Exhibit OR1-a

Casefile No: L2200199-SU/SU/SU/D(C)/AMP/M

RE: Casefile L2200199-SU/SU/SU/D(C)/AMP/M - First Open Record Period Comment

Figure 1: Tax Map 1N 1 19BC

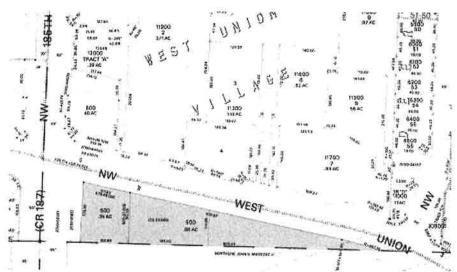
The front lot line on a corner lot is defined in CDC 106-113.1 as the line separating the narrowest frontage from the street right-of-way. The site's frontage on NW 185th Avenue is approximately 123 feet, while the site's frontage on NW West Union Road is approximately 654 feet. Per CDC 106-113.1, the site's front lot line is the frontage abutting NW 185th Avenue. CDC 106-113.2 establishes that the rear lot line is the line which divides one lot from another opposite from the front lot line. In the case of triangular lots, the rear lot line shall be a line 10 feet in length, within the lot, parallel to and at the maximum distance from the front lot line. The site's rear lot line is the line opposite NW 185th Avenue where a parallel 10-foot line is established.

Figure 2: Front and Street Yard Setbacks

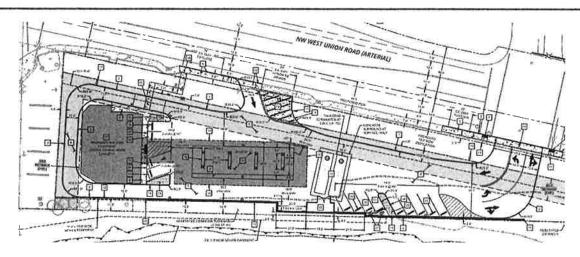
As shown on Figure 2, a 20-foot yard setback has been provided along the site's frontage on NW West Union Road and NW 185th Avenue. The corner of the fuel canopy projects 20 inches into the front yard. Per 418-1.1, eaves may project into a front yard up to 20 inches. The fuel canopy is located approximately 370 feet from the projected 10-foot rear yard line. Though an interior yard is not required along the southern property line, the proposed building is set back 25 feet from the interior lot line. On-site driveways and circulation spaces are not considered structures and are therefore allowed within the setbacks.
